# TB0433 Incorrect Configuration of Air Service Unit

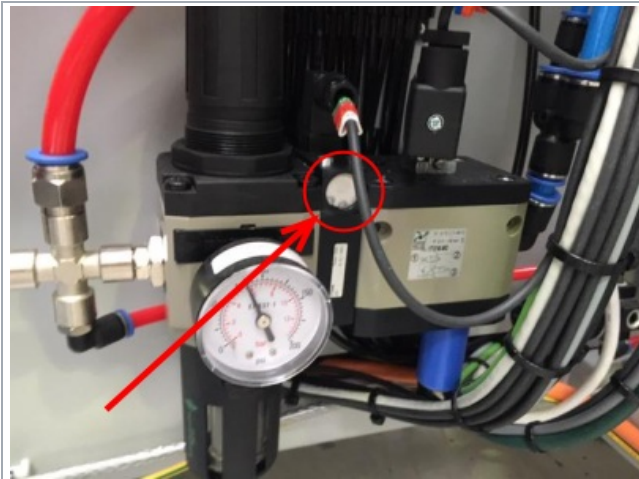
The main picture is correct- dial setting is visible

This bulletin demonstrates the incorrect orientation of the pressure sensor dial on an air service unit. This is a regular supply issue. If an item is received like this, it must be returned to the supplier for replacement. If the unit is needed urgently, it will have to be dismantled and rebuilt correctly.

Incorrect- dial is not visible

Correct
